Access Compliance Report Public Rights-of-Way (Curb Ramps)

Main Street: UNIVERSITY_AVE Cross Street: FARMHOUSE Location: SE

ADA ID: RPRK220223163449 Ramp Type: Type 1 - Perpendicular Initial Pass/Fail: Pass Overall Compliance: No Severity Score: 16

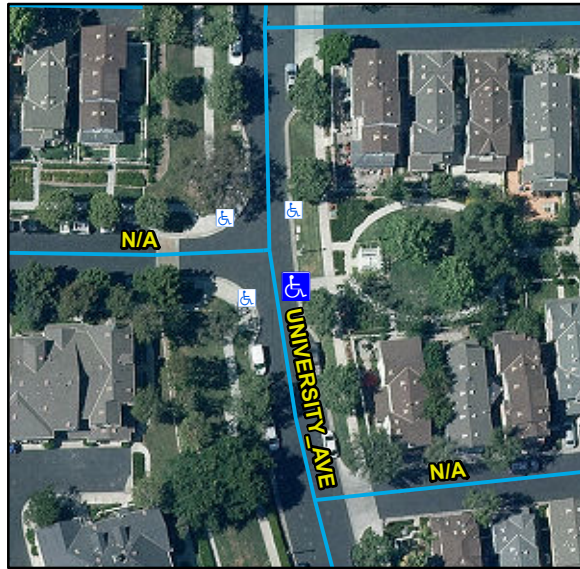
Install Detectable Warning System. Remove & Replace Gutter.

N/A	Ramp Inside Crosswalk 1	N/A	Yes	Ramp Inside Crosswalk 2	N/A
	Crossing 1 Slope (%)	3.8		Crossing 2 Slope (%)	N/A
	Crossing 1 Cross Slope (%)	1		Crossing 2 Cross Slope (%)	N/A
Yes	Gutter Ponding	No	Yes	Curb Slope	0.9
Yes	Gutter Lip Height (in)	0		Road Run Slope (%)	N/A
No	Gutter Run Slope (%)	13.2		Road Cross Slope (%)	N/A
Yes	Gutter Cross Slope (%)	1.8			
Yes	Overall Surface Condition: Acceptable		Yes	Perp Joint Present	Yes
	Cross Gutter Present?	No		Spandrel Present?	No
	Replace Cross Gutter?	N/A		Replace Spandrel?	N/A
